# Validation Report

## Validation of CDM project for Jirau Hydro Power Plant

LRQA Reference : TCNOV110236\_GDFJIR\_B  
report version 03.1  
Date : 18 September 2012  
Work carried out by : Iuri de A. Barroso  
Hilton Carvalho  
Work verified by : Talita Beck  
Steve Ross  
Javier Vallejo Drehs  
Andrew Ritchie

Figure 1: IPCC (2011) comparison of Life Cycle GHG emissions of different energy generation technologies

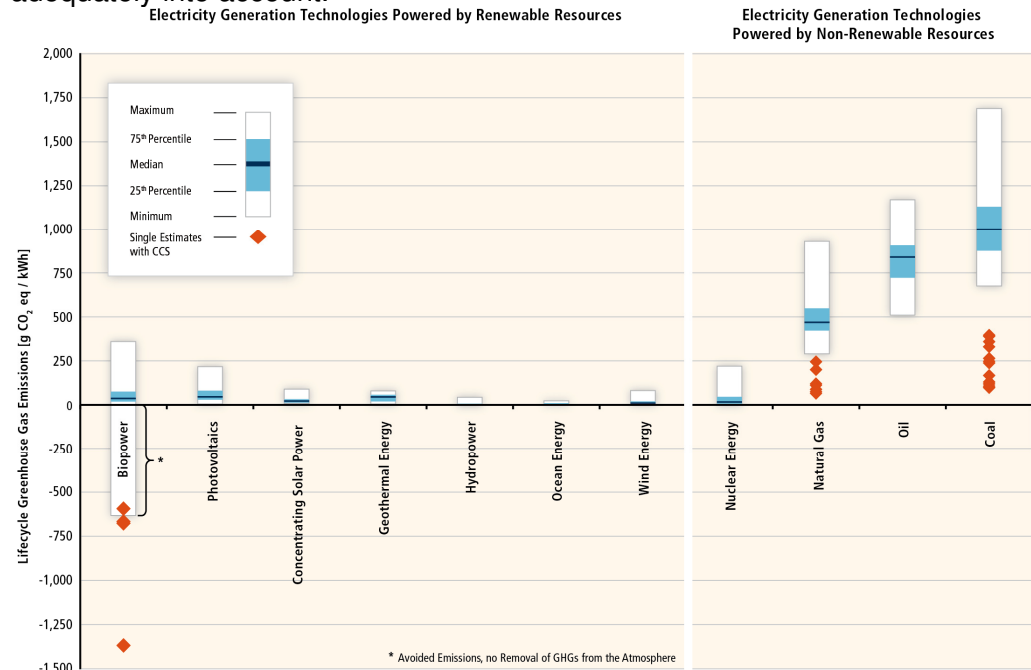
Response submitted by the PP	<p>A representative literature review for Life Cycle Emissions (LCA - Life Cycle Assessments) of hydro power and other energy sources has been conducted by the IPCC (2011) to assess GHG emissions from reservoir and run-of-river hydro power plants. The study is clear by expressing that "The LCAs evaluated in this assessment only accounted for gross LUC (Land Use Change)-related emissions. Characterizing a reservoir as a net emitter of GHG implies consideration of emissions that would have occurred without the reservoir, which is an area of active research". Now in spite of this limitation, the IPCC has identified hydro power and especially run-of-river plants to have the lowest GHG emissions of all commercially available electricity generation sources, including wind and solar. Graph 9.8 of the publication is replicated below in Figure 1. The comparison is also interesting because it shows the increased advantage of hydro power from the perspective of Life Cycle Assessments where the emission intensities of Gas, Coal and Fuel oil generated electricity are significantly higher than the emission factors which are used to calculate the emission reductions which are calculated and certified on the basis of UNFCCC methodologies. Though this is an obvious fact due to the large direct (coal mine gas, flaring and venting of natural gas and associated gas) and indirect emissions (production, transport, refinery) related to the production of fossil fuels, this issue (and therefore this benefit of renewable energies) gains only reduced attention while the discussions around GHG emissions from hydro power plants is emphasized without taking the recent scientific progress</p>

adequately into account.

The validation team has confirmed that, according to a literature review conducted by the IPCC (2011), i.e. the *IPCC Special Report on Renewable Energy Sources and Climate Change Mitigation*, prepared by Working Group III (available at: <http://srren.ipcc-wg3.de/report>), that run-of-river hydro power plants have very low lifecycle land use (chapter 9, page 744) and that hydro power has one of the lowest lifecycle GHG emissions between all the electricity generation technologies powered by renewable resources (chapter 9, figure 9.8, page 732).

**Figure 2: Evolution of deforested area in Rondônia State 1988-2011**

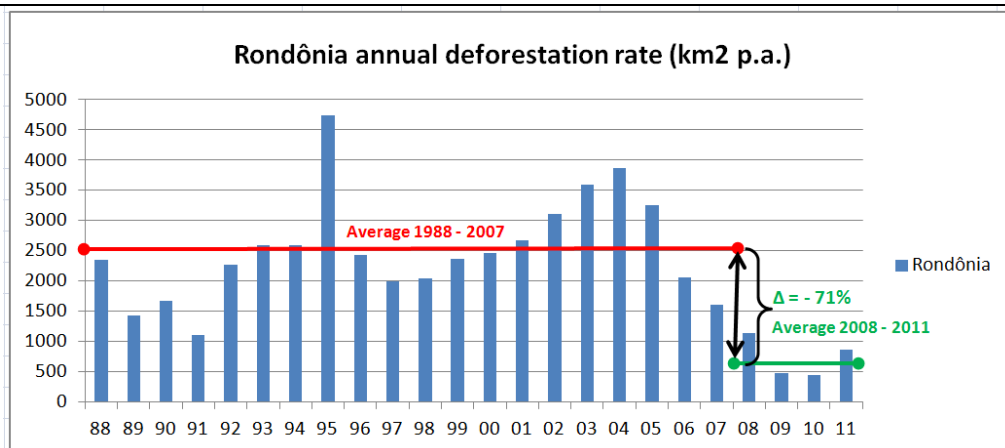
<p>Comment</p>	<p><u>Philip Fearnside, page 4:</u></p> <p>"One unmentioned impact with relevance to greenhouse-gas emissions is the dam's providing a link in a series of planned industrial waterways that would promote the advance of soybeans into rainforest areas in Brazil and especially in Bolivia, thus causing emissions and other impacts from deforestation (Kileen, 2007; Molina Carpio, 2005; Vera-Diaz et al., 2007). In addition to future deforestation expected upstream for soy in areas to be served by the waterways, current deforestation rates have skyrocketed in the immediate vicinity of Jirau and the adjacent Santo Antônio Dam: this area was the number one hotspot of deforestation in Amazonia in December 2010 (Angelo &amp; Magalhães, 2011; Hayashi et al., 2011)."</p> <p><u>Zachary Hurwitz, page 5:</u></p> <p>"Deforestation and reduction of conservation areas. The PDD ignores official data on the increased incidence of deforestation associated with the Jirau HPP. The Brazilian Instituto Nacional de Pesquisa Espacial (INPE) attributed a doubling in the rate of deforestation in the state of Rondônia during 2010-2011 to the construction and implementation of the Jirau HPP and Santo Antônio HPP further downstream. The deforestation is explained both by direct intervention in forested areas by the project proponent as well as by an increase in forest asset extraction as a result of labor market migration induced by the HPP. In addition, in 2009, 140,000 hectares of the "Reserva Estadual do Rio Vermelho" protected area were reduced in order to accommodate the Jirau HPP. To offset the reduction, 140,00 hectares were added to the existing "Reserva Federal do Rio Pardo." Yet only 70,000 hectares of the offset area consisted of forested land, while the remaining 70,000 hectares consisted of land for agricultural production occupied by 5,000 families. The resulting effect was a net loss of 70,000 hectares of forested areas attributable to the Jirau HPP."</p>

<p>Response submitted by the PP</p>	<p>To understand and assess the criticisms raised by Fearnside and IR it is important to consider that the key motors of deforestation in the Amazon region are poverty, lack of employment opportunities and the non-enforcement of environmental laws, all of which lead to illegal logging and deforestation mainly for cattle raising activities. The state of Rondônia has traditionally been a hotspot for these activities and for decades has presented one of the highest deforestation rates in the country. According to the results of the Program of Deforestation Assessment in Brazilian Legal Amazonia of the National Institute of Space Research (INPE) historically monitored data signals that deforestation in Rondônia state was definitely higher between the 1980s and the beginning of 2000. The Figure 2 below shows annual deforestation rates between 1988 and 2011.</p>

As it can be seen, in 1995 deforestation in Rondônia State achieved its highest and most impressive deforestation point - of approximately 4,700 km<sup>2</sup> – at a time lacking effective governmental monitoring, supervision and control of deforestation and illegal mining and extracting activities. However, deforestation in Rondônia decreased significantly after 2007 and reached an average deforestation rate below 730 km<sup>2</sup> between 2008 and 2011, a reduction of more than 71% compared to the average deforestation rate in the period 1988-2007
